Technical Note

Project No: ITB13091
Project Title: The Landings, Ford Airfeild
Title: Stage 1 Road Safety Audit
Ref: DS/ITB13091-034 TN
Date: 23 November 2020

Road Safety Audit Report

Proposed Yapton Road Access Roundabout & works along Rollaston Park and Burndell Road Ford Airfield

Location: Proposed Roundabout, Yapton Road

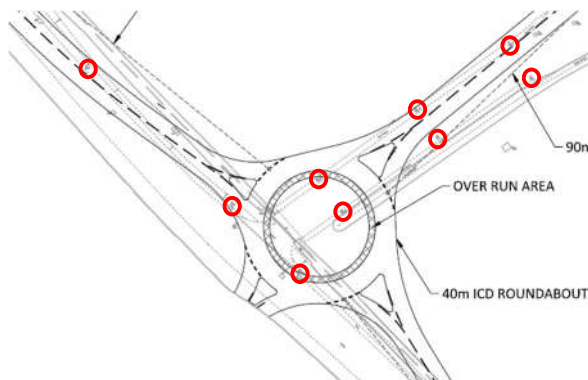
Summary: Introduction of proposals impact on the surface water drainage network

The carriageway within the vicinity of the proposed works is bounded by soft verges which accommodate gullies. The proposals realign / widen the existing carriageways and introduce a three-arm roundabout. No details have been provided to identify that the existing surface water drainage network is to be modified in accordance with the proposals or that provision will be made to accommodate the additional surface water that is generated. An inadequate surface water network could result in ponding during inclement conditions which may give rise to loss of control type incidents which would be exacerbated during freezing conditions.

DESIGN ORGANISATION RESPONSE provided by i-Transport on the 7th October 2020 following formal issue of this Stage 1 Road Safety Audit on the 22nd September 2020

Location: Drake Grove

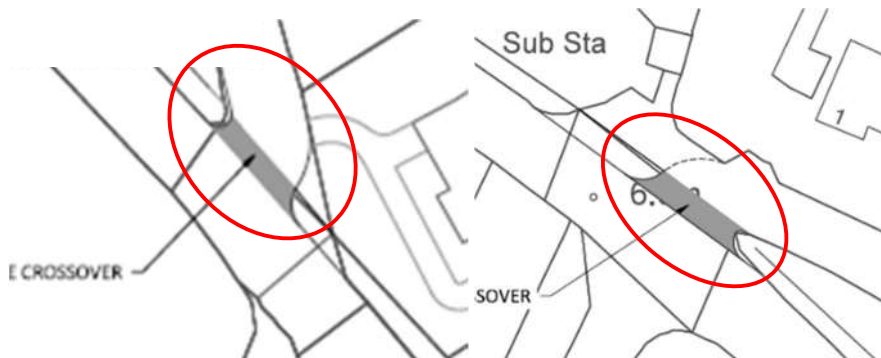
Summary: Proposals will not allow for the smooth transition of pedestrians or vehicles

The speed limit of Yapton Road reduces from 40mph to 30mph approximately 60 metres to the south of Rollaston Park and continues as Burndell Road which benefits from a footway along the eastern side of the carriageway. The proposals include works to existing crossing points, providing dropped kerbs and tactile paving, as well as, the resurfacing of the Drake Grove priority accesses to provide vehicular crossovers. No details have been provided to identify how the vehicular crossovers will be formed to allow for the smooth transition for pedestrians and vehicles which could give rise to trips and falls. If existing levels are to be retained, the nature of the access is unlikely to change and as such, vehicles may assume priority over pedestrians which could give rise to vehicle pedestrian collisions.

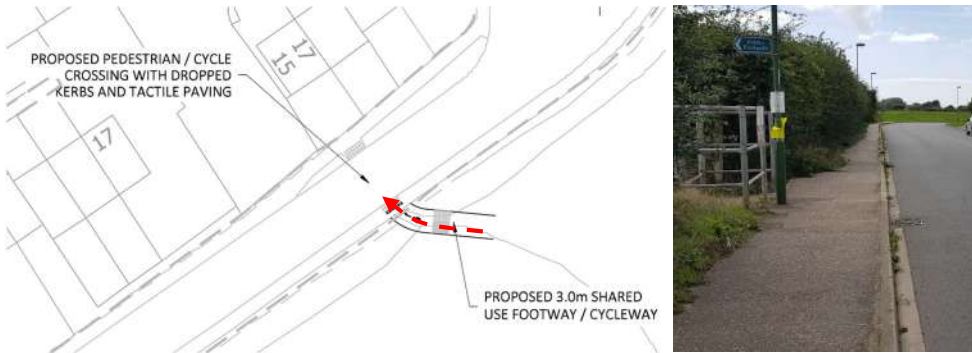
RECOMMENDATION:	
It is recommended that the crossing point and corduroy paving are relocated to ensure that pedestrians travelling from a footway become aware of cyclists	
Location Plan: 	
DESIGN ORGANISATION RESPONSE provided by i-Transport on the 7 th October 2020 following formal issue of this Stage 1 Road Safety Audit on the 22 nd September 2020	
Accepted, the design has been amended to incorporate the recommendation of the Auditor and include the relocation of the crossing point and corduroy paving. This is shown on revised Drawing ITB13091-GA041A.

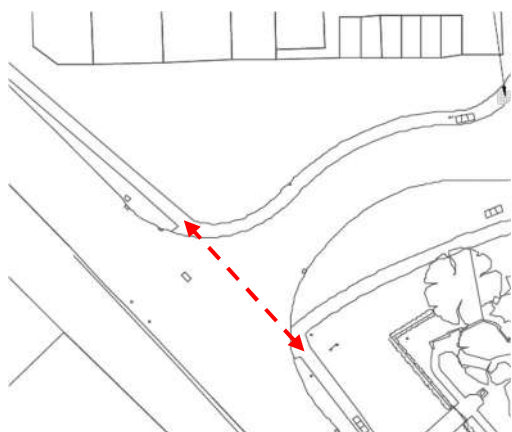
It is recommended that the dropped kerb are adjusted with a maximum upstand of 6mm and tactile warning is provided.

Accepted, the design has been amended to incorporate these recommendations and this is shown on revised Drawing ITB13091-GA-201A.

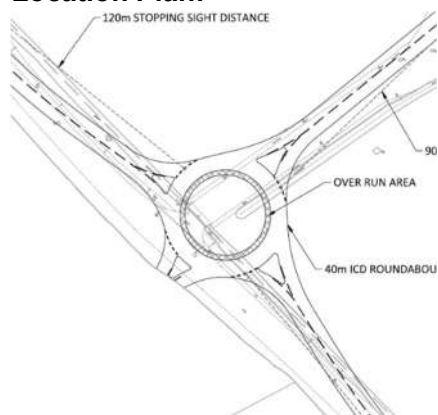
Summary: No street lighting details have been provided with the Audit Brief

Yapton Road is rural in nature, subject to a 40mph speed limit and does not benefit street lighting. The proposals introduce a 40 metre ICD roundabout and realigns the approach carriageways. The scheme drawings provided with the Audit Brief do not identify that street lighting is to be provided. As such, the driver of a vehicles approaching the junction may not become aware of the proposed roundabout at a safe distance which could give rise to heavy braking resulting in loss of control type incidents as well as junction overshoots.

DESIGN ORGANISATION RESPONSE provided by i-Transport on the 7th October 2020 following formal issue of this Stage 1 Road Safety Audit on the 22nd September 2020

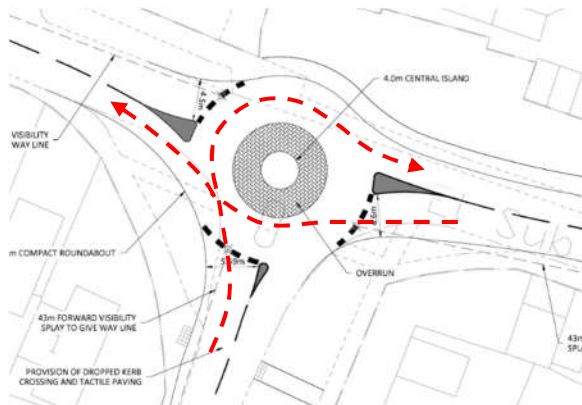
It is recommended that the junction allows for the expected manoeuvres.

Accepted - the junction allows for all expected manoeuvres as shown in Drawing ITB13091-GA-062.

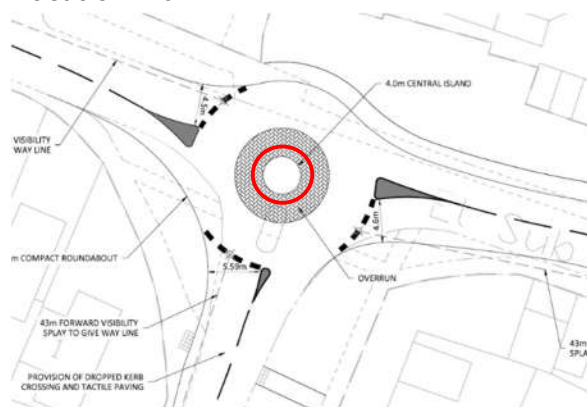
Summary: Drivers may not become aware of the compact roundabout and physical central island

The junction of Bilsham Road with Burndell Road is street lit and benefits from mini roundabout and give-way signage on each approach as well as a pedestrian refuge on Bilsham Road and painted splitter islands on Burndell Road. The proposals provide a 20-metre ICD compact roundabout to include a 4-metre kerbed central island, an overrun area and painted splitter islands on each arm relocating the existing uncontrolled crossing further south along Bilsham Road. The scheme drawing provided with the Audit Brief does not include any measures to highlight the presence of the physical central islands or the junction itself and as such, there is a risk that drivers will not become aware of the kerbed features at a safe distance which could give rise to a vehicle striking the physical island and a loss of control type incidents.

Accepted – signage has been introduced on the approach to the junction and the treatment of the central island will be considered further alongside the Overseeing Organisation as part of the detailed design. Amendments are shown on Drawing ITB13091-GA-027C.

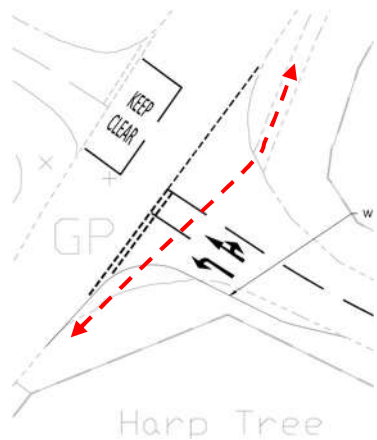
The highway network in proximity of the North End Road mini roundabout junction with Main Road is subject to a 30mph speed limit and accommodates vegetation in the verges which is overgrown and encroaching the public highway in places. The proposals subject to this Stage 1 Road Safety Audit include the provision of 20-metre ICD compact roundabout that includes painted splitter island on each approach in place of the mini roundabout with physical splitter islands on each approach. The scheme drawing illustrates that 43 metre forward visibility splays are achievable to the give-way of both the North End Road and Main Road approaches in accordance with the 30mph speed limit of the road. However, due to the existing alignment of the approaches and presence of the overhanging vegetation, the level of forward visibility is limited. Insufficient visibility for a vehicle approaching a give-way line of the entry to the roundabout could give rise to heavy braking, loss of control type incidents and junction overshoots.

Accepted, the physical splitter islands will be made more visible and details of this will be provided at the details design stage.

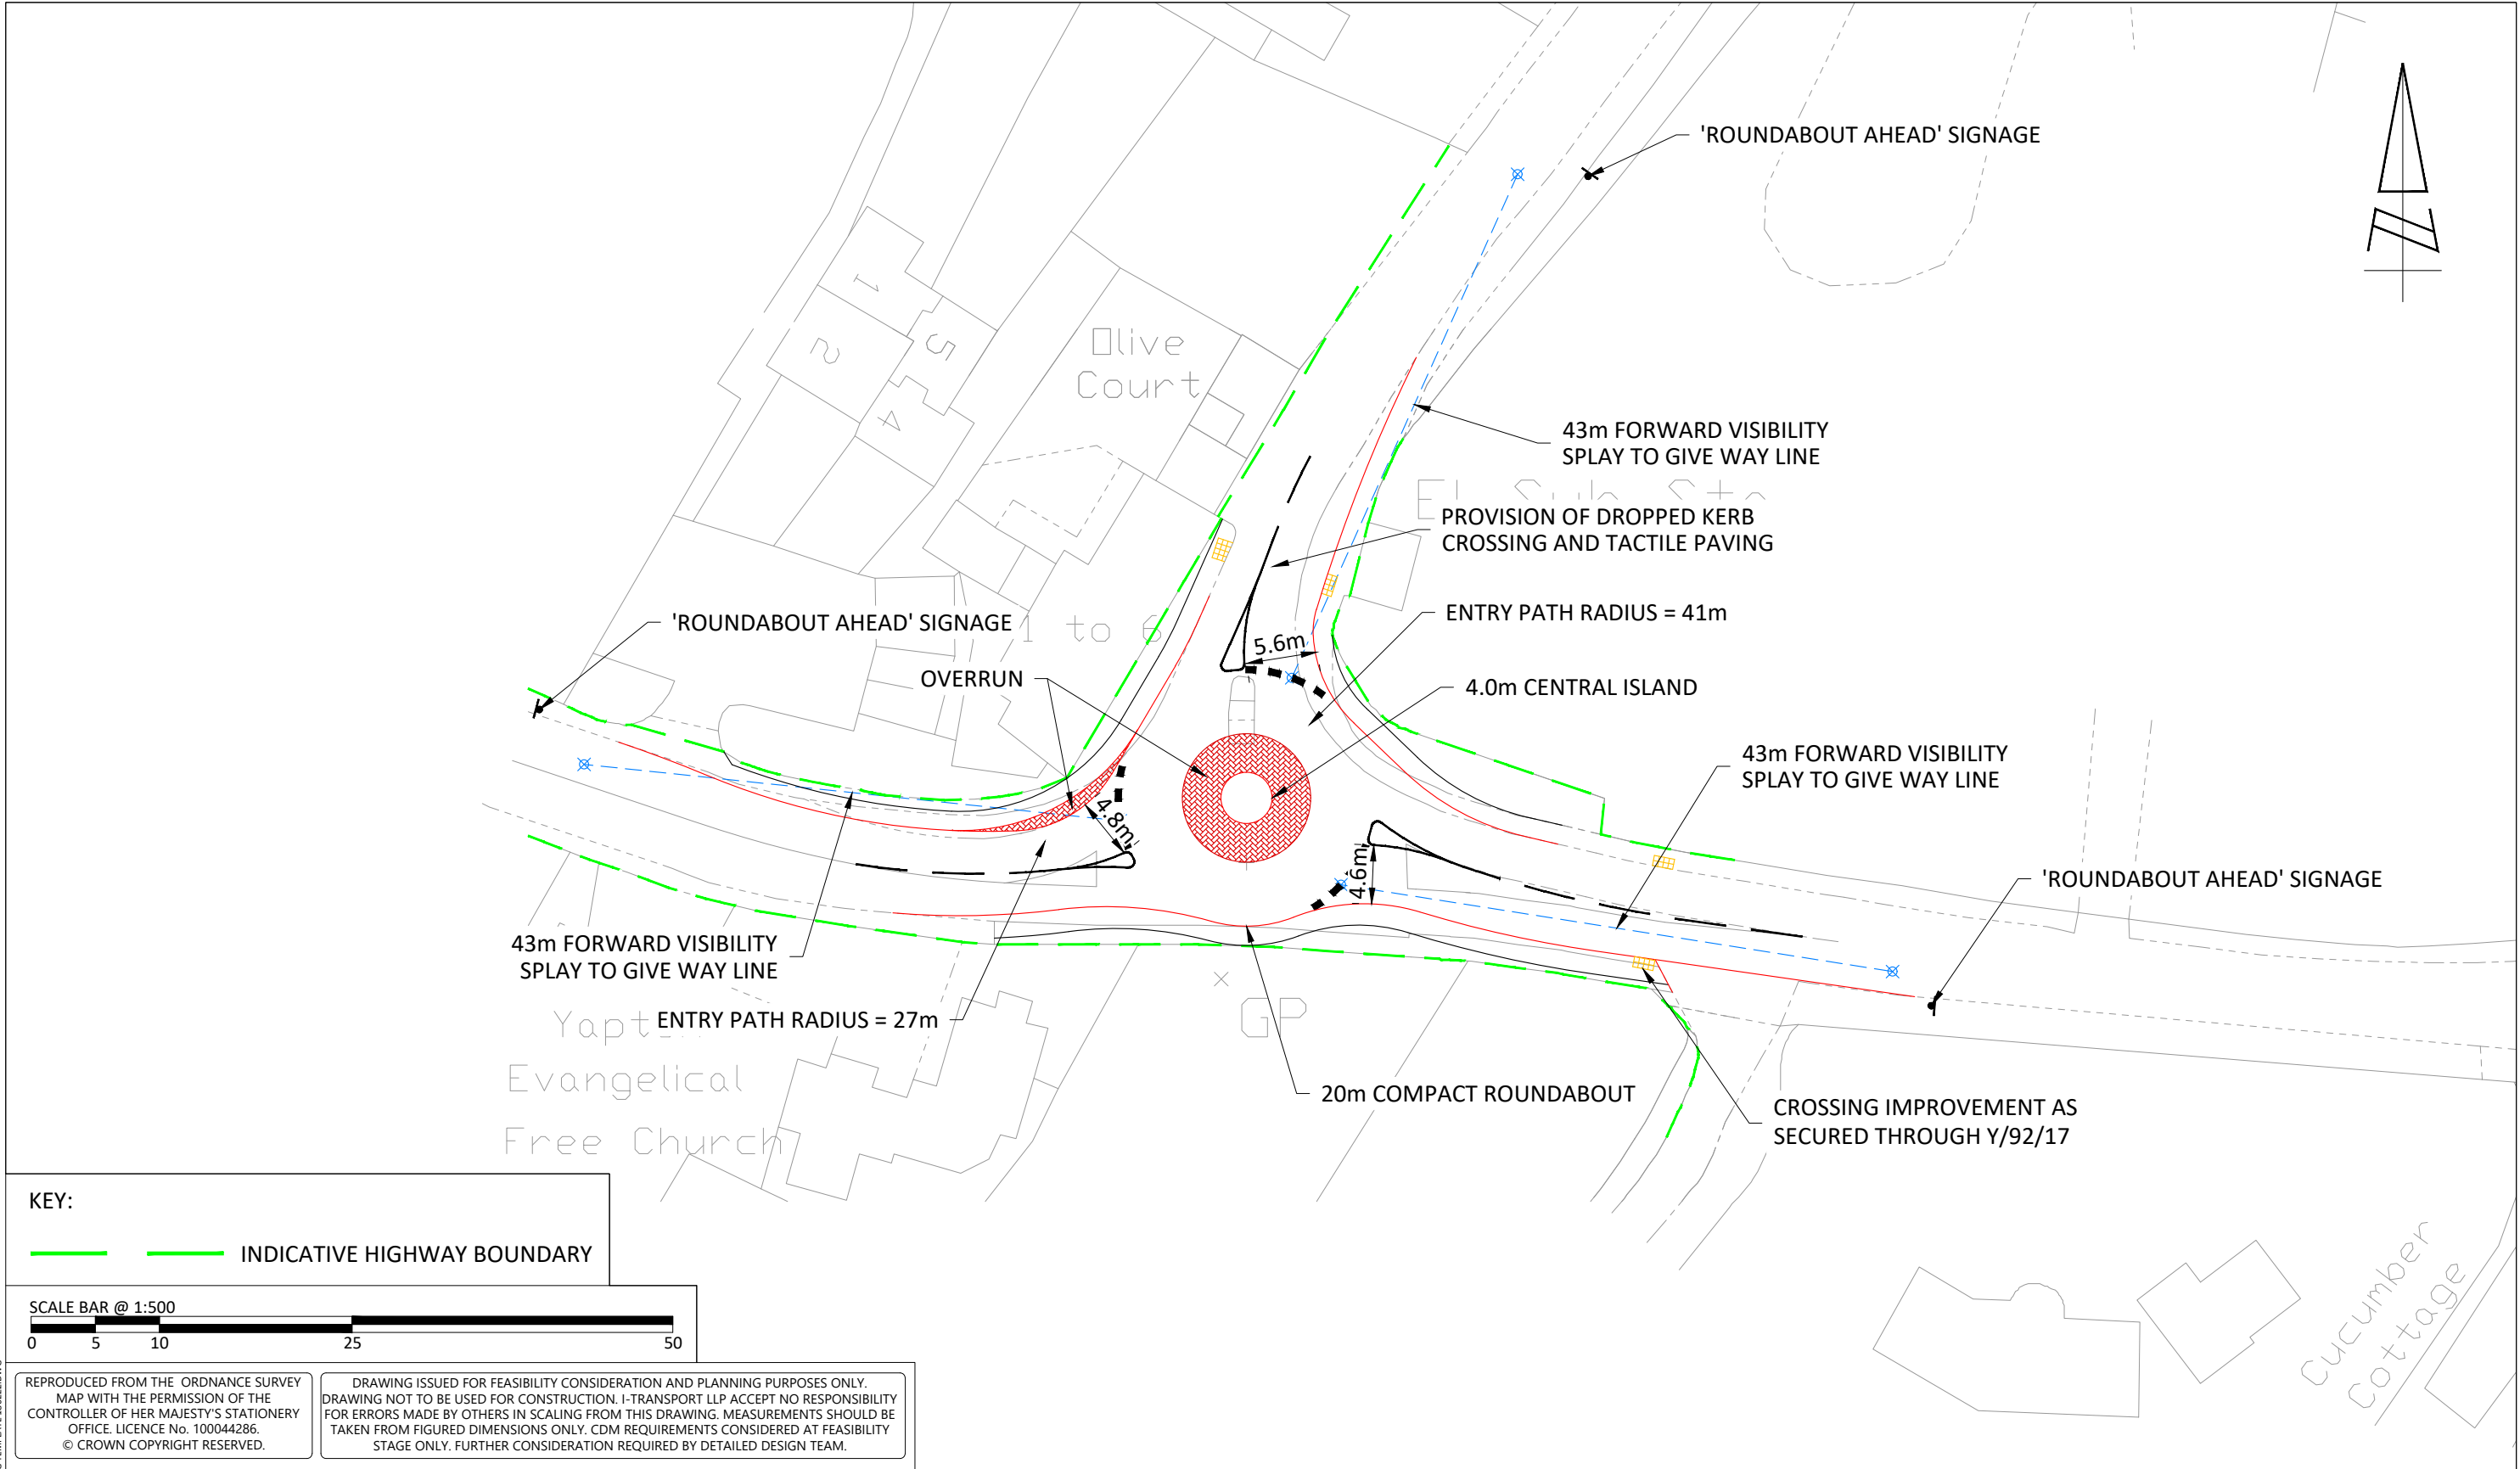
RECOMMENDATION:	
It is recommended that measures are provided to ensure approaching drivers become aware of the junction, need to give-way and physical central island.	
Location Plan: 	
DESIGN ORGANISATION RESPONSE provided by i-Transport on the 7th October 2020 following formal issue of this Stage 1 Road Safety Audit on the 23rd September 2020	
Accepted, appropriate signage will be provided on the approach to the roundabout and this is shown on revised Drawing ITB13091-GA-026B.

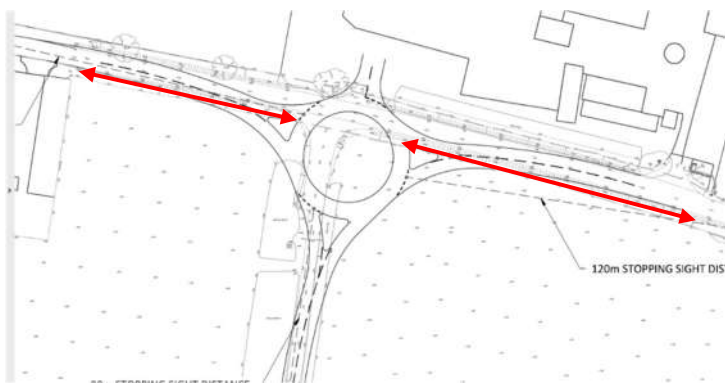
A.1	LOCAL ALIGNMENT
A.1.1	PROBLEM
Location:	Ford Lane
Summary:	Southbound vehicles could encroach the kerbline which forms a reverse curve
Acc Type:	Loss of control
Ford Lane is a two-way single lane carriageway road which accommodates a number of accesses to local residential, agricultural and commercial properties. The proposals subject to this Stage 1 Road Safety Audit include the realignment of the Ford Lane carriageway in order to provide a 4-arm roundabout with the southern arm forming the development access and northern arm allowing access to a proposed anaerobic digestate plant. The scheme realigns each of the Ford Lane approaches and introduces a footway along the frontage of Wicks Cottages to the north of Ford Lane to the east of the proposed roundabout. The scheme drawing provided with the Audit Brief identifies that the provision of the footway on the northern side of the carriageway will introduce a kink in the alignment. The driver of a vehicle continuing along this section of Ford Lane may not become aware of the kink at a safe distance and could clip the edge of the carriageway / kerb which could give rise to loss of control type incidents.

RECOMMENDATION:	
It is recommended that the transition allows for a smooth alignment.	
Location Plan:  	
DESIGN ORGANISATION RESPONSE provided by i-Transport on the 7th October 2020 following formal issue of this Stage 1 Road Safety Audit on the 23rd September 2020	
Accepted – the transition has been amended to allow for a smooth alignment and shown in drawing ITB13091-GA-054 Rev A.
